**TRANSMITTAL OF RESPONSES TO OHIO ENVIRONMENTAL PROTECTION
AGENCY COMMENTS TO RESPONSES TO COMMENTS ON THE FERNALD
GROUNDWATER CERTIFICATION PLAN, REVISION 0**

**RESPONSES TO
OHIO ENVIRONMENTAL PROTECTION AGENCY
COMMENTS ON THE
FERNALD GROUNDWATER CERTIFICATION PLAN
FINAL, REVISION 0, OCTOBER 2005**

**FERNALD CLOSURE PROJECT
FERNALD, OHIO**

**OHIO ENVIRONMENTAL PROTECTION AGENCY COMMENTS ON THE
FERNALD GROUNDWATER CERTIFICATION PLAN,
FINAL, REVISION 0**

FIGURE 9-1. LONG-TERM MONITORING WELL LOCATION MAP

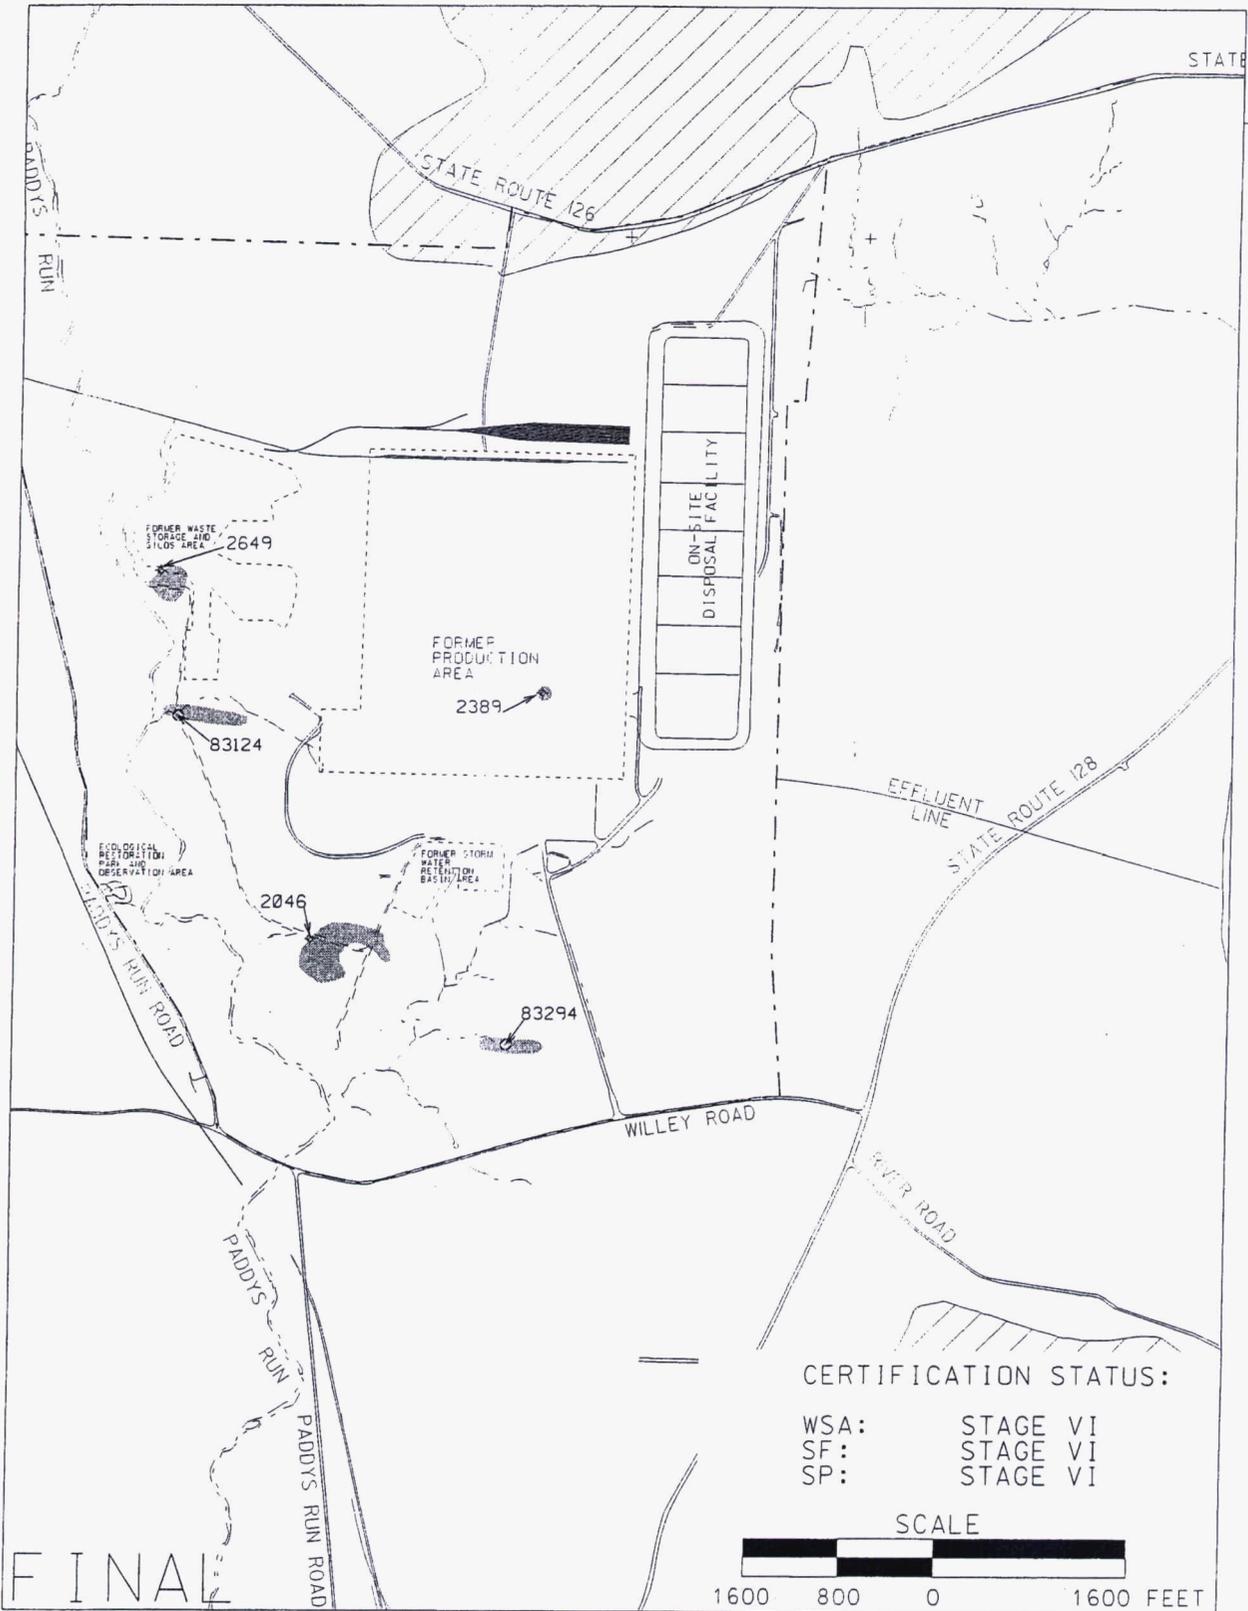
2. Commenting Organization: Ohio EPA Commentor: GeoTrans, Inc.
Section #: 9.1 Pg #: 9-1 Line #: 4 Code: C
Original Comment #: 12
Comment: The key objective of the long term water level monitoring is to ascertain whether high water levels exist in the source areas. Elevated water levels may result in concentration rebound by the release of sorbed contaminants in the unsaturated zone. Based on available site data, rebounding concentrations are a very real possibility. Accurate assessment of source area water levels is, therefore, critical and should not be based on remote measurements. As noted in the original comment, unforeseen changes to water levels are possible, particularly given the long period of time involved in this monitoring task. Although the proposed long term monitoring approach using the OSDF wells is

clearly more convenient with respect to implementation, the potential for a false negative (the conclusion that source area water levels are low when the opposite is true) is clear. The source area water level monitoring should be conducted at the source areas.

Response: This comment is the same as Original Comment #91 on the LMICP. Data was presented in Section 9 of the Certification Plan that illustrates that the OSDF aquifer-monitoring wells will serve as good indicators for rising water levels in the aquifer beneath former source areas. Regardless of this data, DOE will commit to monitor water levels in the former source areas identified in Figure 9-3 of the Certification Plan. This will include one well in each of these five former source areas; Waste Storage area, Pilot Plant Drainage Ditch Area, Former Southern Waste Units Area, South Field Area, and Plant 6 Area.

Action: Section 9 of the Certification Plan has been revised to reflect a strategy of monitoring water levels in the former source areas. Revised Section 9 of the Fernald Groundwater Certification Plan is attached.

The monitoring network will consist of the 5 Great Miami Aquifer groundwater-monitoring wells (Monitoring Wells 2649, 83124, 2046, 2389, and 83294), as shown in Figure 9-1. Any needed additional sampling in the former source areas would be accomplished using a direct-push sampling tool.
